CONTRACT CHANGE ORDER

CCO 1	Suppl. No. 0	Contract No. 04 - 0120F4	Road SF-80-13.2/13.9	FED. AID LOC.:

TO: PETER SIEGENTHALER / Gary Pursell	FILE: **E.A.** 04 - 0120F4
FROM: Gary Pursell	**CO-RTE-PM** SF-80-13.2/13.9
	FED. NO.
CCO#: 1 SUPPLEMENT#: 0 Category Code: **AJZZ**	CONTINGENCY BALANCE (incl. this change) **$148,069,580.00**
COST: **$100,000.00** INCREASE ☑ DECREASE ☐	HEADQUARTERS APPROVAL REQUIRED? ☐ YES ☑ NO
SUPPLEMENTAL FUNDS PROVIDED: **$100,000.00**	IS THIS REQUEST IN ACCORDANCE WITH ENVIRONMENTAL DOCUMENTS? ☑ YES ☐ NO
CCO DESCRIPTION: Flagging & Traffic Control	**PROJECT DESCRIPTION:** CONSTRUCT SELF-ANCHORED SUSPENSION BRIDGE

LOCATION: IN SAN FRANCISCO COUNTY IN SAN FRANCISCO FROM 0.6 KM TO 1.3 KM EAST OF THE YERBA BUENA TUNNEL EAST PORTAL

CONTRACT CHANGE ORDER NO. 11
SHEET 6 OF 13

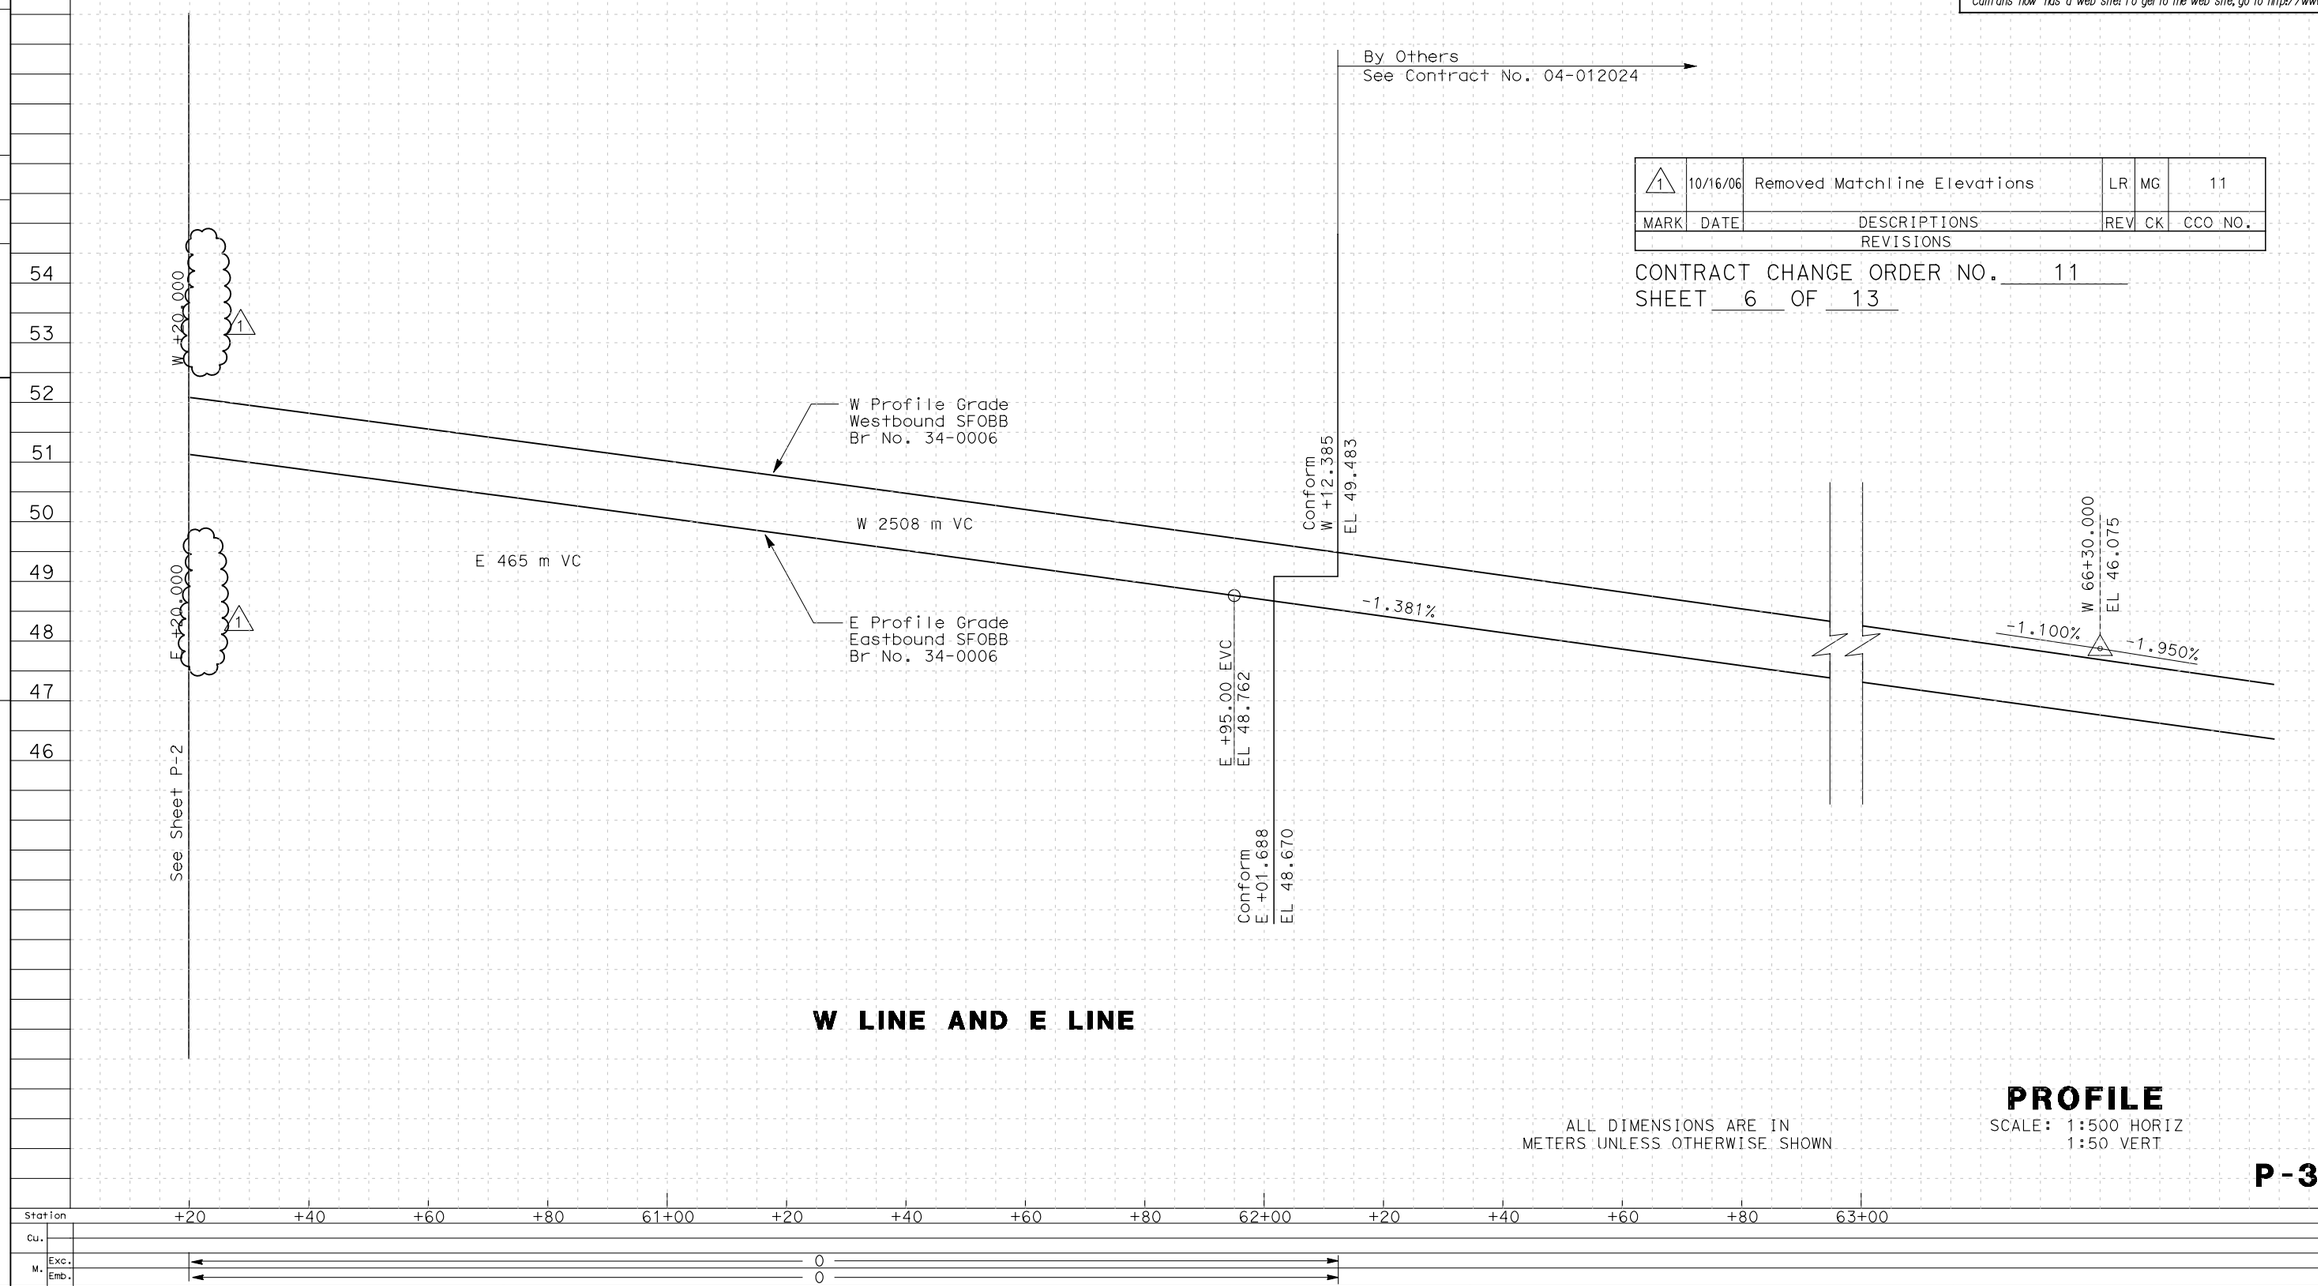
1. Revise Project Plan Sheet Numbers 5, 6, and 7 of 1204, as shown on sheets 4, 5 and 6 of this change order.
2. Revise Plan sheet numbers 97, 98, and 99 of 1204 (E-14, E-15, and E-16) to reflect revised electrical manhole elevations, as shown on sheets 7, 8 and 9 of this change order.
3. On plan sheet number 132 of 1204: SHEET NOTE 5 should reference "Sheet No. 965 of 1204" instead of "Sheet No. 934 of 1161", as shown on sheet 10 of this change order.
4. On plan sheet numbers 133 and 208 of 1204: SHEET NOTE 3 should reference "Sheet No. 965 of 1204" instead of "Sheet No. 934 of 1161", as shown on sheets 11 and 12 of this change order.
5. On Project plan sheet number 233 of 1204: Revise electrical notation number 3 to read : "Ground cable shall be installed along full length of the 15 KV cable tray only", as shown on sheets 13 of this change order.

MARK	DATE	DESCRIPTIONS	REV	CK	CCO NO.
1	10/16/06	Removed Matchline Elevations	LR	MG	11

CONTRACT CHANGE ORDER NO. 11
SHEET 6 OF 13

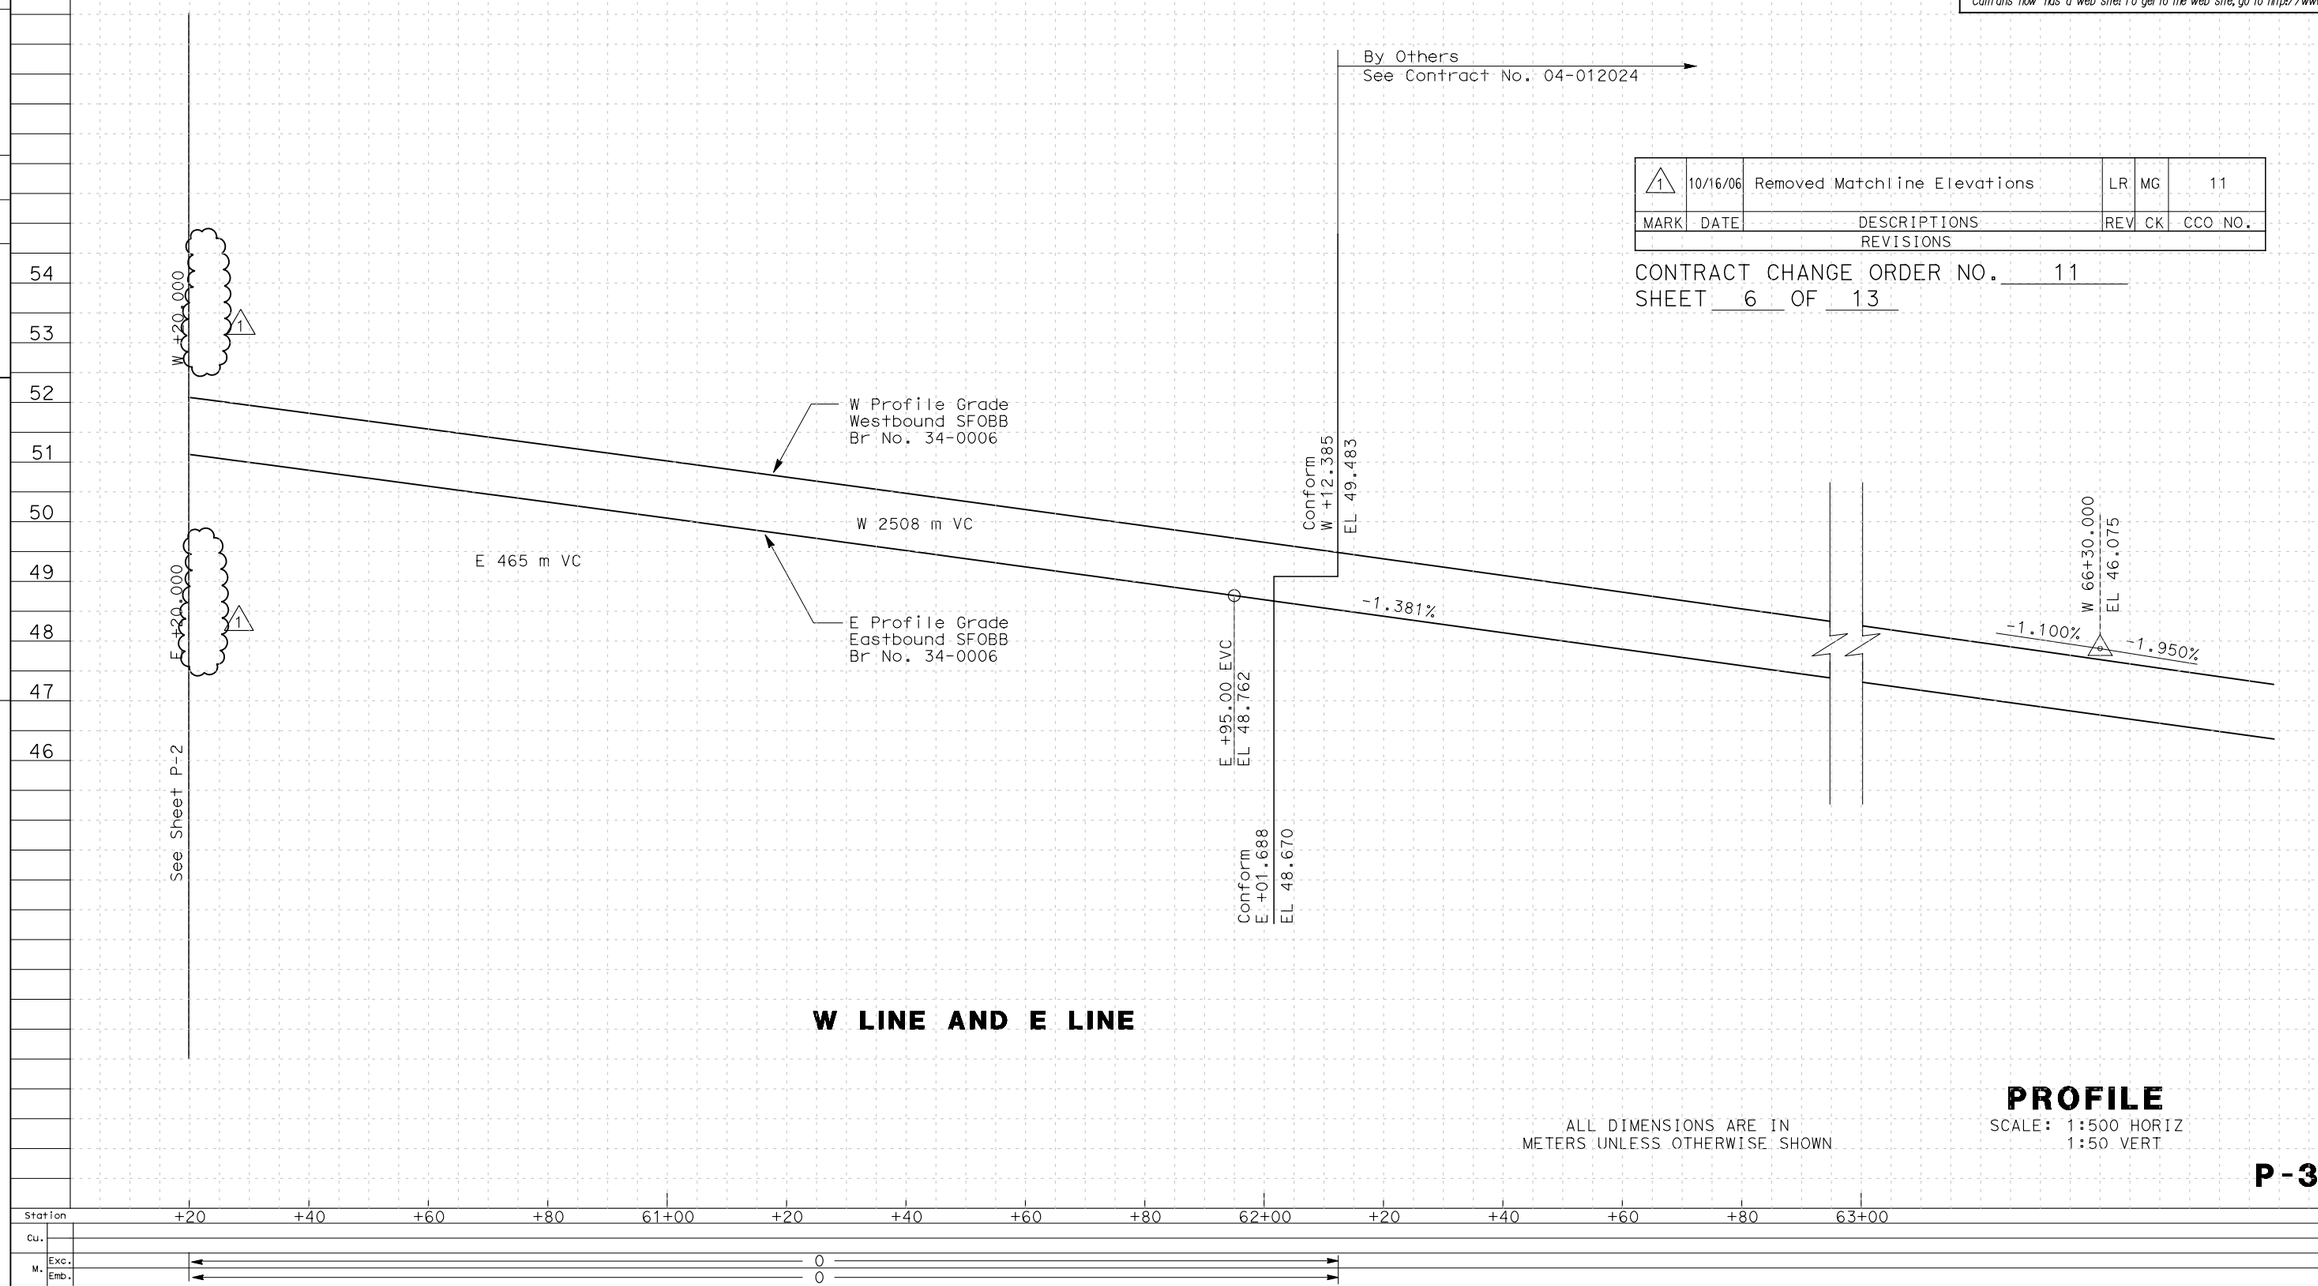
MARK	DATE	DESCRIPTIONS	REV	CK	CCO NO.
1	10/16/06	Removed Matchline Elevations	LR	MG	11

REVISIONS

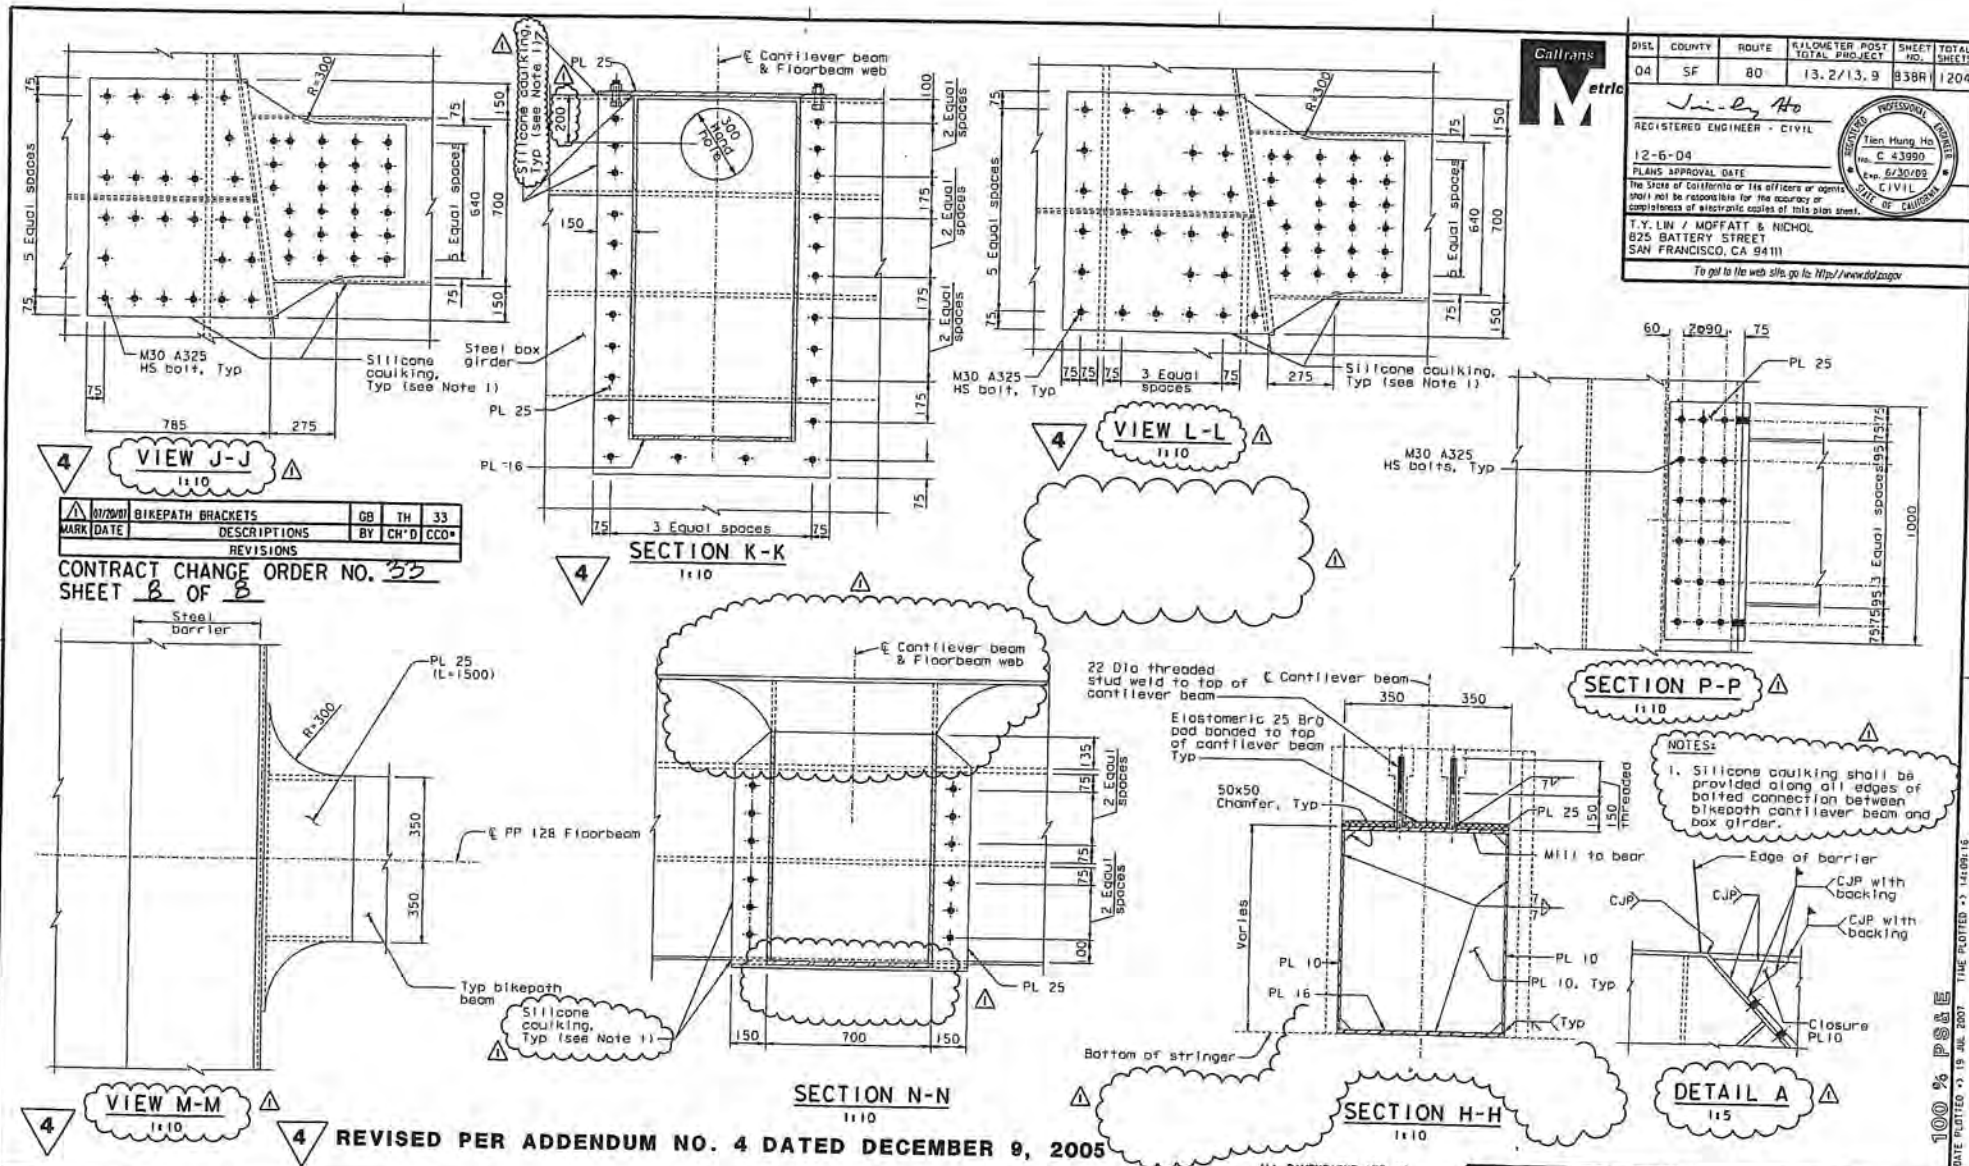
MARK	DATE	DESCRIPTIONS	BY	CH'D	CCO#
1	07/20/07	BIKEPATH BRACKETS	GB	TH	33

5 **DETAIL E** (Note: In the plane of the Deviation saddle)
1:30

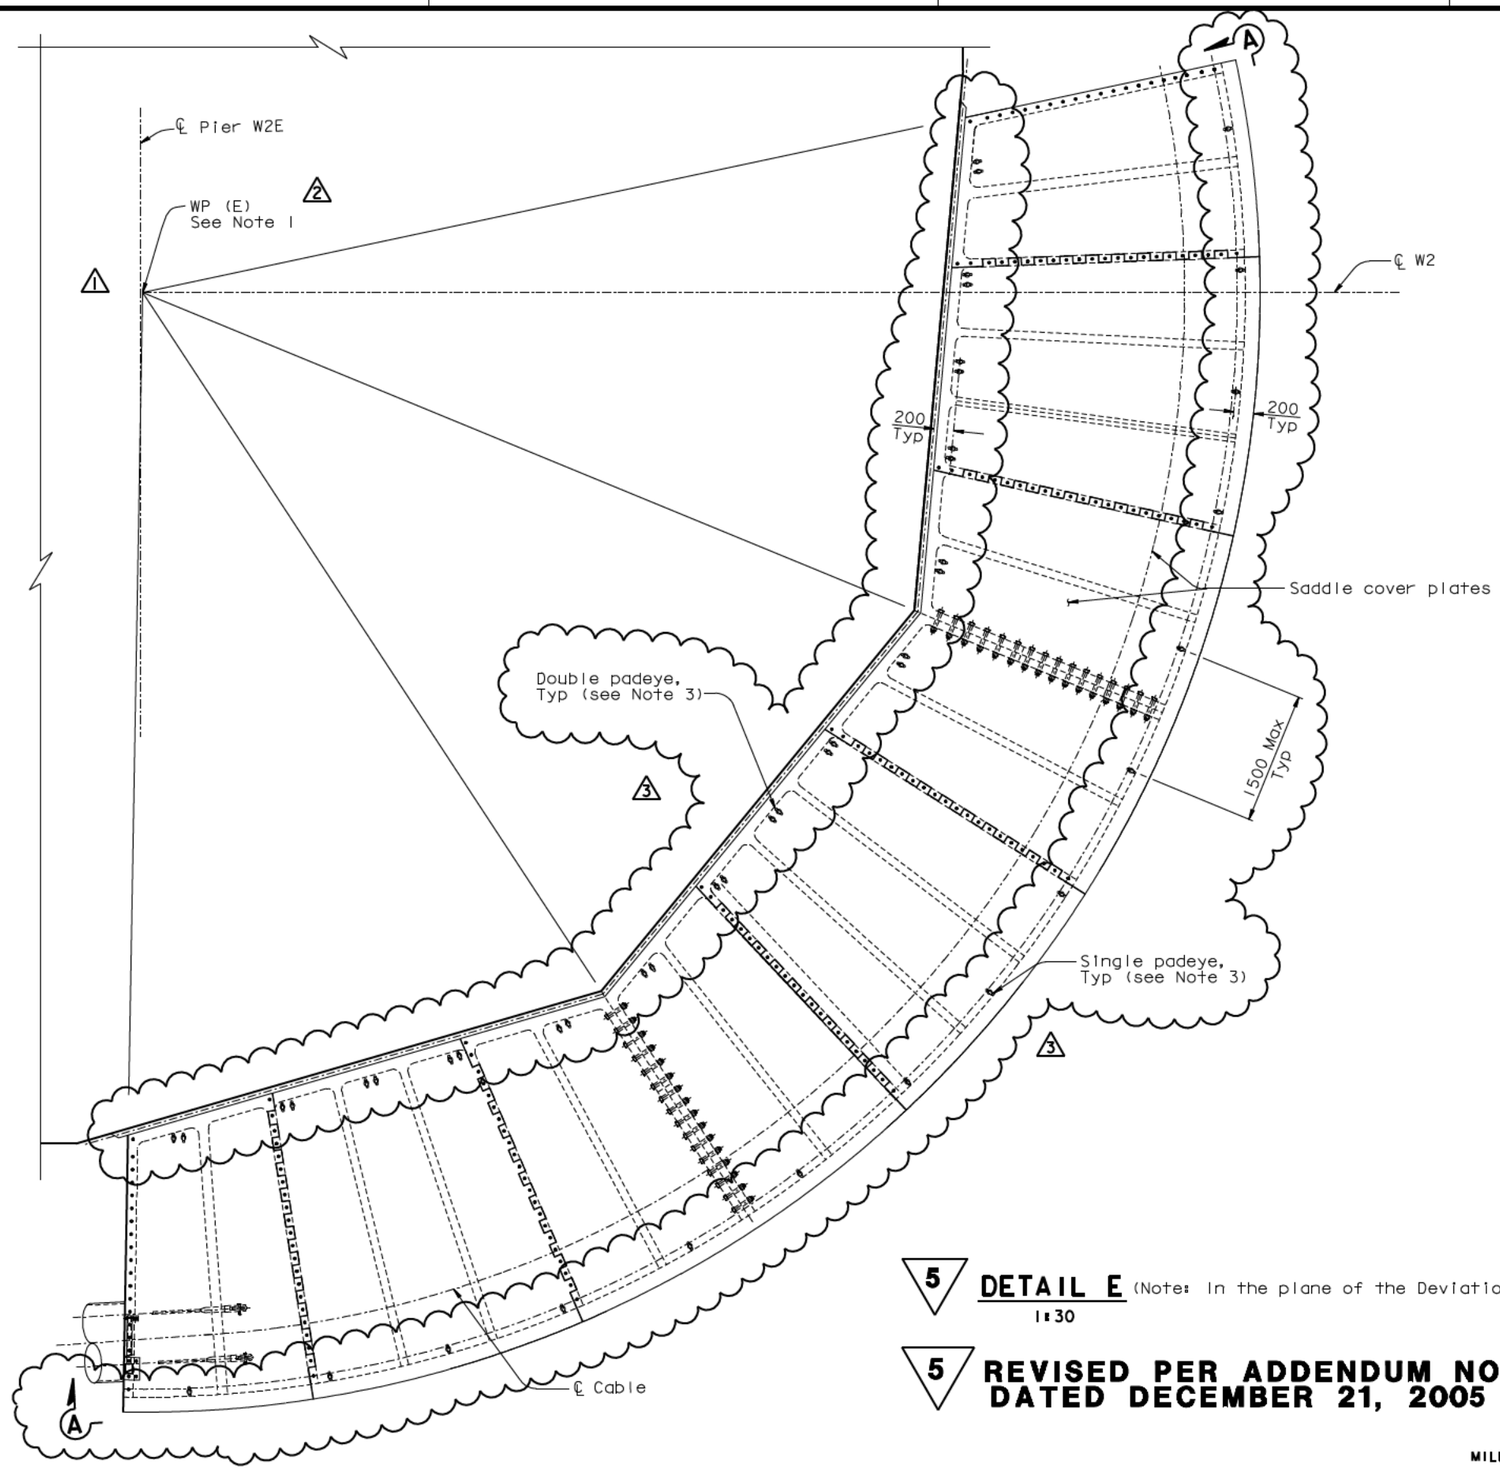
5 **REVISED PER ADDENDUM NO. 5 DATED DECEMBER 21, 2005**
